To
Conrad
Editor-in-Chief
ESSD Copernicus
Manuscript ID: ESSD -2025-200

We hereby submit our revised manuscript, “**CAMELS-COL: A Large-Sample Hydrometeorological Dataset for Colombia,**” authored by David A. Jimenez, Julian E. Meneses, Pedro H. Bernardes Solha, Alvaro Avila Diaz, Benjamin Quesada, Bruno Melo Brentan, André Ferreira Rodrigues to be considered for publication in *Earth System Science Data (ESSD)*.

Reply to reviewer 1

Figure 1. Results of the watershed delineation for basin 23207070. The official national stream network of Colombia is shown in blue, and the watershed boundary obtained from the delineation process is shown in red.

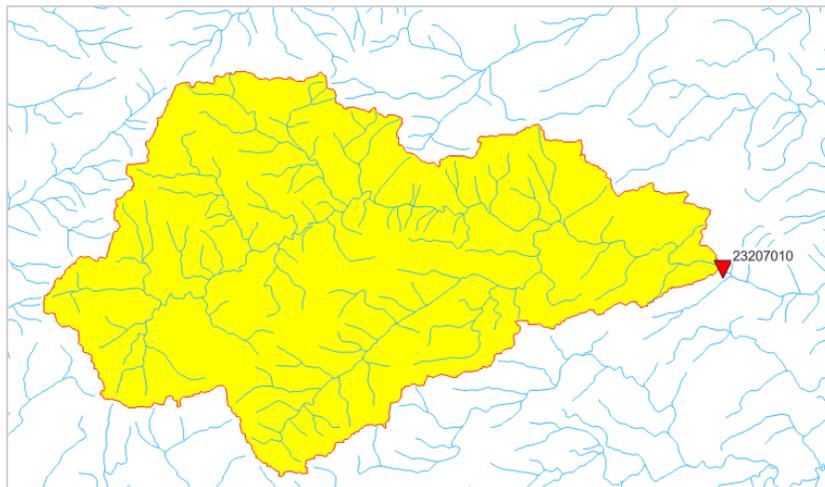
2. Line 137: Did you correct the gauge locations? This is a common issue identified in previous CAMELS studies. If so, please explain the process used to reduce this uncertainty/error. Also, what was the resolution and source of the stream network used to delineate the drainage areas?

Response 2: Yes, gauge locations were systematically verified after completing the basin delineation in order to reduce uncertainties associated with potential gauge misplacement. This verification was conducted using Colombia's official national stream network dataset (Base de Datos Vectorial Básica de Colombia, scale 1:25,000; 2022 edition) and cross-validated against high-resolution satellite imagery (see Figure 1). (Base de datos vectorial básica de Colombia, scale 1:25,000, year 2022), validated through image-based cross-verification with high-resolution satellite data from Google Earth.

In addition, hydrological consistency was evaluated by analyzing drainage area continuity and mean discharge relative to neighboring upstream and downstream gauges along the same river system. When necessary, minor adjustments to the streamflow station location were applied to ensure consistency between gauge location, river topology, and observed streamflow characteristics [Lines 149 - 156].

Figure 2. The delineation of the 13077030 basin does not include the upstream area associated with gauge 13067020, which should be included. It is caused by a discontinuity in the streamflow network estimated from the DEM. This type of discontinuity was mainly observed in low-relief areas.

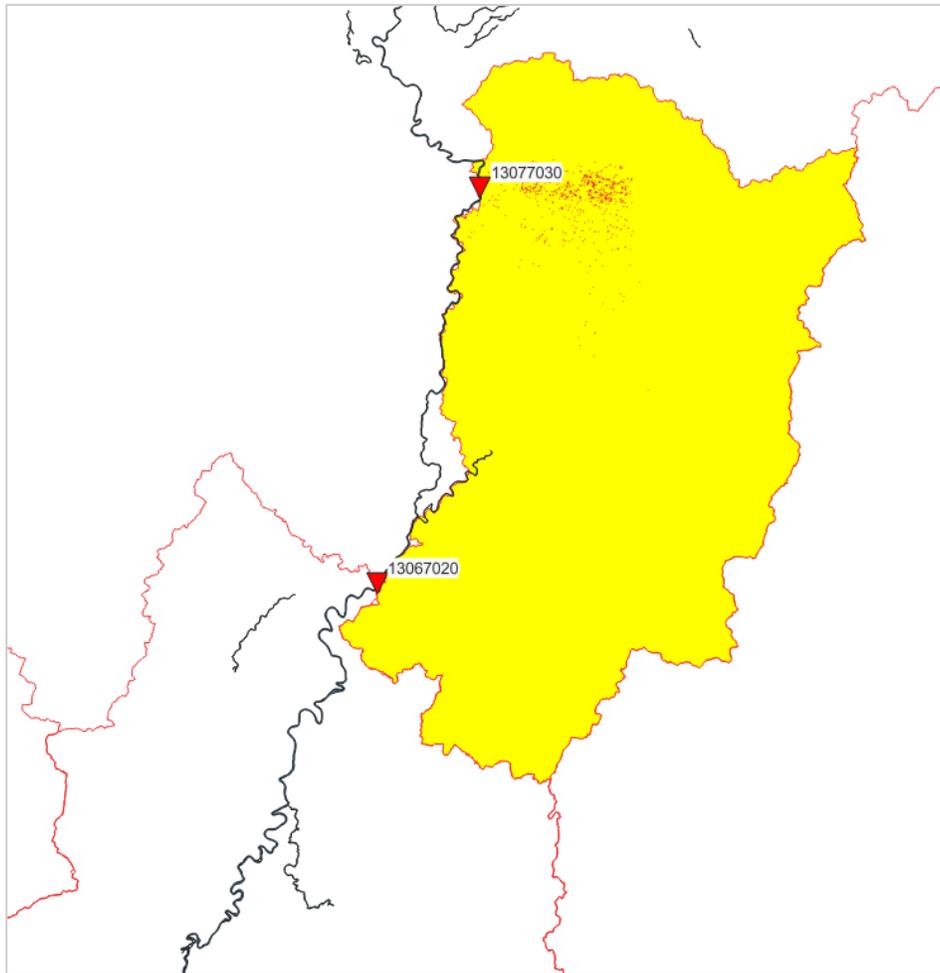
3. Line 139: “Basins with inconsistent delineations were excluded, particularly in cases where inconsistencies were attributed to limitations of the Digital Elevation Model (DEM) used.” How was the delineation process evaluated? Please include supplementary figures to show the results. Did you compare the watershed delineations with IDEAM’s official hydrological zonification or global datasets such as hydroSHEDS (<https://www.hydrosheds.org/products>)?

Please check the watershed delineation for streamflow gauge 13077030. I see some inconsistencies in the shapefile.

Response 3: Regarding streamflow gauge 13077030, the watershed delineation was found to be inconsistent due to limitations of the Digital Elevation Model (DEM) used. As a result, this basin was excluded from the analysis to avoid introducing additional uncertainty (See Figure 2). Thank you for noticing this.

Most delineation issues were concentrated in low-relief and flat areas, where DEM-based flow direction algorithms are known to perform poorly. In particular, some basins located in flat regions exhibited an underestimation of upstream contributing areas, effectively excluding portions of the headwaters. This behavior was especially evident in the lower Magdalena–Cauca region, where minimal elevation gradients and complex drainage patterns increase the uncertainty of automatic watershed delineation [Line 166-177].

Figure 3. Watershed delineation. A) boundary estimated from the 90 m DEM resolution (1115,25 km²). B) boundary estimated from the 30 m DEM resolution (1114,66 km²)

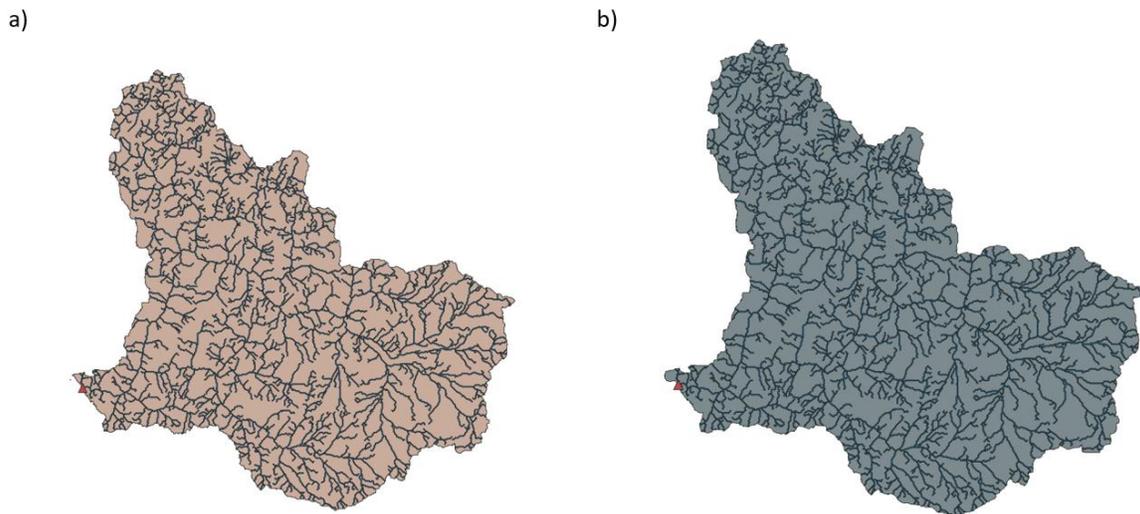
14. Line 136. I am curious if there are changes in watersheds delineation using a DEM with a 90 m spatial resolution.

Response 14: To address this question, a randomly selected watershed was used for comparison (Basin: 23067060 of CAMELS-COL). The watershed was first delineated using the Copernicus Digital Elevation Model (DEM) with 90 m spatial resolution and then compared with a watershed delineation obtained from a 30 m resolution DEM provided by the Instituto Geográfico Agustín Codazzi (IGAC), which is used in CAMELS-COL.

The results indicate that no significant differences were observed between the two delineations. Although minor differences may exist in flat or low-relief areas, the watershed boundaries are highly consistent overall, as shown in Figure 3.
